SPECIAL MEETING - AGENDA

RE: Chester Heights Fire Dept.
JOB NO.: 22-322
CHANGE ORDER REQUEST: 12
RE: Front Door at top of ramp

RE: Chester Heights Fire Dept.
JOB NO.: 22-322
CHANGE ORDER REQUEST: 15
RE: sidewalk step and railings

RE: Chester Heights Fire Dept.
JOB NO.: 22-322
CHANGE ORDER REQUEST: 16
RE: site fill and seed

7035 THERMAL SASH

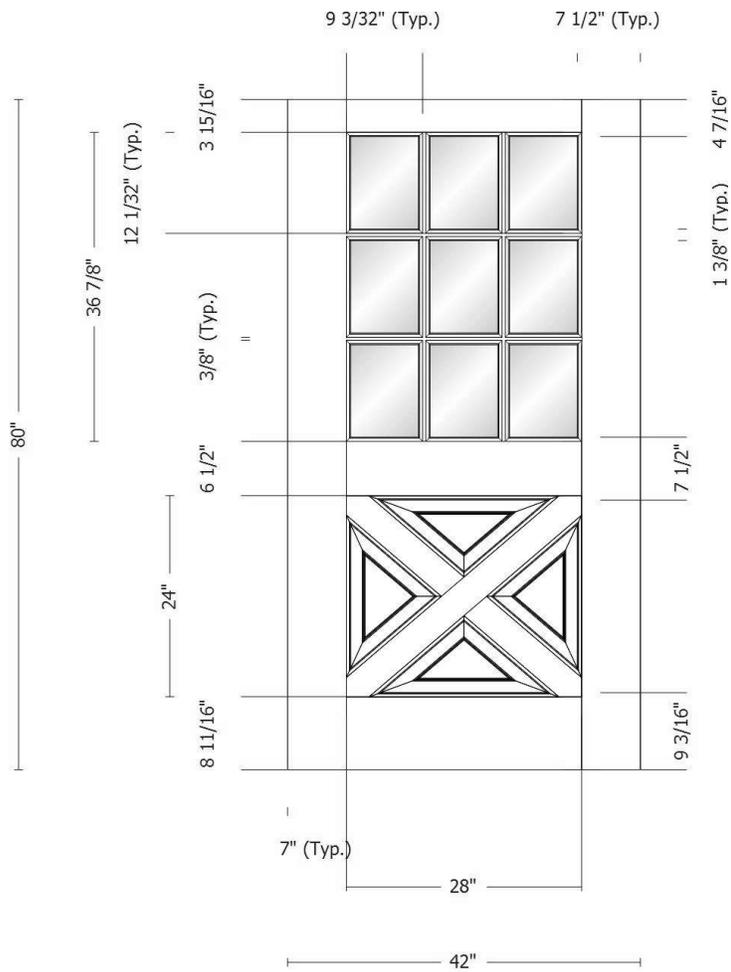
- To keep with the same style of the existing Fire House door we propose to remove existing door in its entirety
- Remove existing door frame and saddle exposing existing brick
- Install new wood door with insulated glass windows 42" x 80" tall with all new door frame and door sill
- Door make – Simpson Door Company Wood Species - Fir
- Build out the area from new frame to brick with pressure treated lumber and Azek wrapped material trim for maintenance free from exposure to weather
- Paint door and trim to match existing trim on Fire House
- Remove existing electronic lock and reinstall in new door
- Door to match existing
- Hinged right inswing left to right
- Photo of door and specs attached
- All work will be completed at prevailing rate

7035 THERMAL SASH

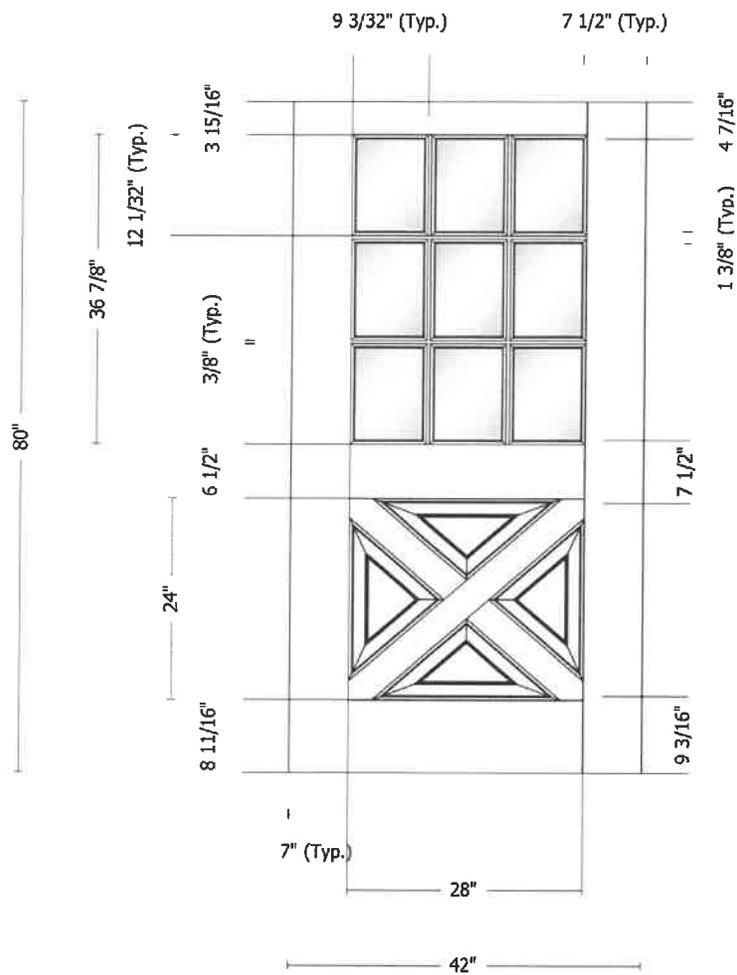
- To keep with the same style of the existing Fire House door we propose to remove existing door in its entirety
- Remove existing door frame and saddle exposing existing brick
- Install new wood door with insulated glass windows 42” x 80” tall with all new door frame and door sill
- Door make – Simpson Door Company Wood Species - Fir
- Build out the area from new frame to brick with pressure treated lumber and Azek wrapped material trim for maintenance free from exposure to weather
- Paint door and trim to match existing trim on Fire House
- Remove existing electronic lock and reinstall in new door
- Door to match existing
- Hinged right inswing left to right
- Photo of door and specs attached
- All work will be completed at prevailing rate
